ARCHITECTURAL REVIEW BOARD STAFF REPORT

Project Name	Rooftop Solar Criteria for a New Category of Countywide Certificate of Appropriateness
Review Type	Work Session
Proposal	To establish design criteria for rooftop solar installations in the Entrance Corridor Overlay District to be used by staff in the review of Countywide Certificate of Appropriateness applications.
ARB Meeting Date	April 20, 2026
Staff Contact	Margaret Maliszewski

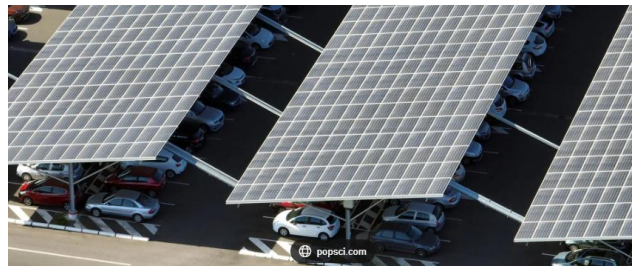
4. ARB members asked if 6” clearance between panels and pitched roofs is workable with current and future technologies.

A general internet search showed that 4-6” spacing is typical. The following clearances were also found in the codes of other Virginia localities:

- Chesapeake: system must not be more than 8” from surface of roof to face of panel.
- Richmond: panels may not extend more than 6” above the roof surface.
- Smithfield: panels should be mounted less than or equal to 6” above the surface of the roof.
- Williamsburg: panels should not project greater than 12” above the roof surface.

Also, the Virginia Asphalt Services solar design approved by the ARB included panels approximately 4” above the roof surface. Based on this information, the 6” clearance was retained.
